4903Permit1992 - Batch No. _____

Re: Landfill Submittal

The Division of Solid Waste Management recently completed its review of the site plan application for the proposed Iredell County Solid Waste Management Facility located north of U.S. Highway 70 off State Road 2319. Based upon information submitted and revised through November 16, 1992, the Division determined that the applicant may prepare a construction plan application for a specific approved disposal area defined below. The Division requires the submittal of a construction plan application for the proposed MSWLF prior to issuing a Permit To Construct. The construction plan application shall meet the rules and requirements of 15A NCAC 13B and Policy Memorandum No. 18 as well as the specific conditions set forth in this letter. These specific conditions address:

Re: Revised Geological And Hydrogeological Study Report For The
Proposed Iredell County Sanitary Landfill

Potentiometric Map
(Table 1)

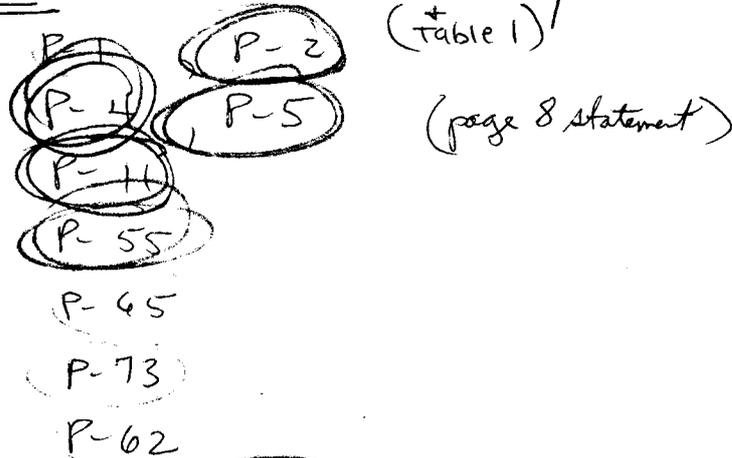
5/6 revised based on additional data being measured

The second important issue is the potentiometric data for the site. No water table data has been incorporated into the potentiometric map for the lower (northern) portion of the site. Additional water table data should be presented and incorporated into a revised ground water contour map. The present potentiometric map has some discrepancies in water table data and the ground water contours for some areas of the site. There appears to be an absence of data or an inaccurate portrayal of the data for a number of borings as indicated on the copy of Table 1, attached with this letter.

to allow these two issues to be resolved. Groundwater table levels have been monitored with time and these data used to prepare a revised groundwater potentiometric map. Single-level groundwater monitoring wells are considered suitable to monitor the groundwater. Nesting of groundwater monitoring wells is not considered necessary.

Figure 4. Proposed northern terminus and regional relationships of the Kings Mountain belt (after Milton, 1981).

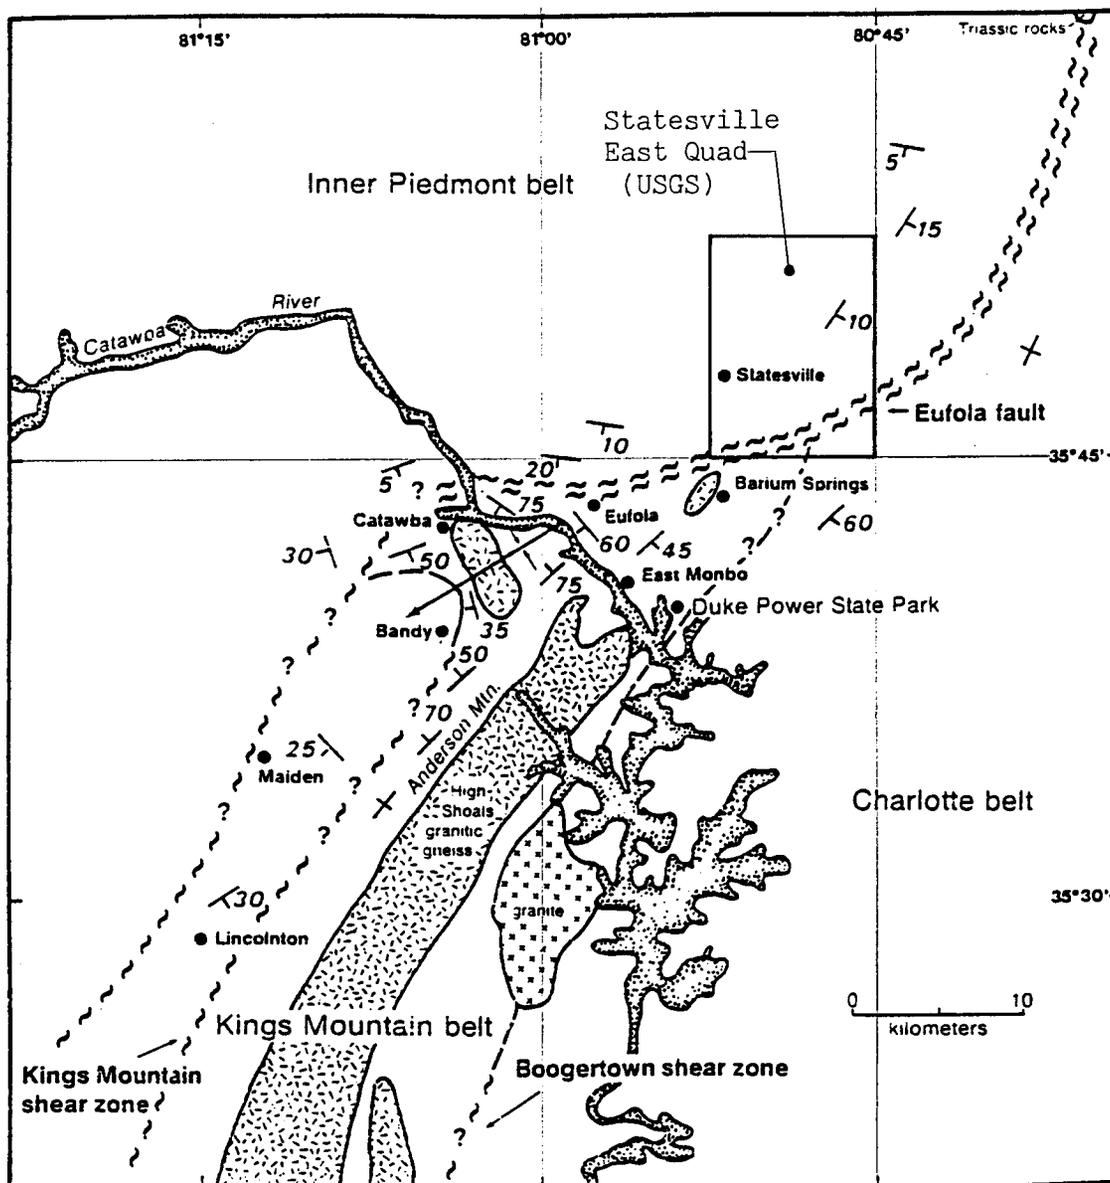
- (a) identifies the exact location of the Eufola Fault in respect to the site. Should the fault intersect the property, Iredell County shall provide information which explains:
 - 1) if the fault is open or annealed; and
 - 2) if the fault is more conductive or less conductive hydraulically than surrounding materials.

The site plan application needs to be revised to show the exact location of the Eufola Fault. If the fault actually straddles the site, then the application needs to discuss the fault's impact on ground water flow direction and rate. A more extensive literature search may provide some or all of the information needed to answer these questions. However, if the fault does intersect the site to be developed, further field investigation may be necessary.

The thesis contains maps showing the location of the Eufola Fault in the area of the Iredell County Sanitary Landfill Expansion. The location of the Statesville East Quadrangle (USGS) is plotted on Figure 4 from the thesis showing the location of the Eufola Fault (copy enclosed). In addition, the Eufola Fault has been plotted on the USGS Statesville East Quadrangle (copy enclosed). As shown on the Statesville East Quadrangle, the Eufola Fault zone (± 2 km wide) is located south of the planned location for the Iredell County Sanitation Landfill Expansion. A portion of the 2 km wide zone of the Eufola Fault touches the buffer zone of the planned location of the Iredell County Sanitary Landfill Expansion. The Eufola Fault does not straddle or intersect the site based on the location presented in the master's thesis (a detailed mapping and description of definite Kings Mountain Belt Rocks in this area). In addition, as stated in the Geological and Hydrological Study report dated August 25, 1992, no evidence of fault-related detrimental conditions was detected in the borings or rock cores made at the site. Consequently, the Eufola Fault is considered not to impact development of the landfill.
